PARK LIGHTS AND GRAVEL PANS 1955-1956

INST-2240
PART NUMBERS
2240-56, 2240-55
1526-5556

1393 RADIATOR GRILLE LOWER PANEL ASSEMBLIES (1956 Trucks)

Fig. 1 - Parking Light Attaching Bolt Hole - Location (Item 1393)

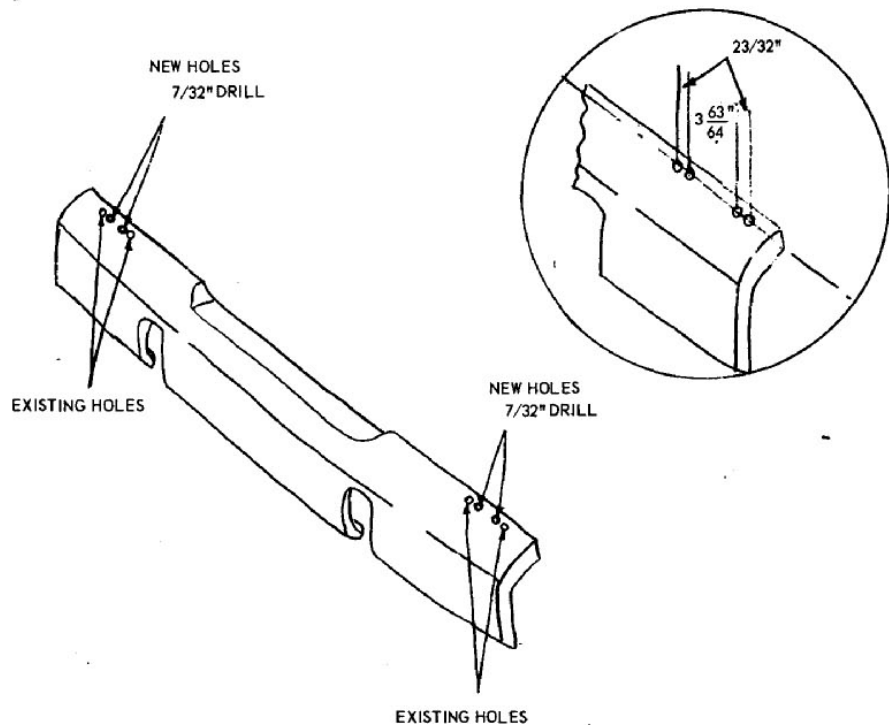
New radiator grille lower panel assemblies (B6C-8188-A and B6TW-8188-A) have been released for service. These assemblies will replace the present radiator grille panel assemblies (B5C-8188-A and B5TW-8188-A), when present stock is exhausted.

To use the new assemblies on the 1955 trucks it will be necessary to relocate the parking light attaching bolt holes by drilling four $7/32$ inch diameter holes, (two per side) in the panel as shown in fig. 1, using the following procedure:

1. Draw a straight line between the centers of the existing parking light attaching bolt holes.
2. On this line and $23/32$ of an inch to the center from each existing hole, drill a $7/32$ inch diameter hole.
3. The new holes will be approximately $3 \frac{63}{64}$ inches apart and equally spaced between the old holes.
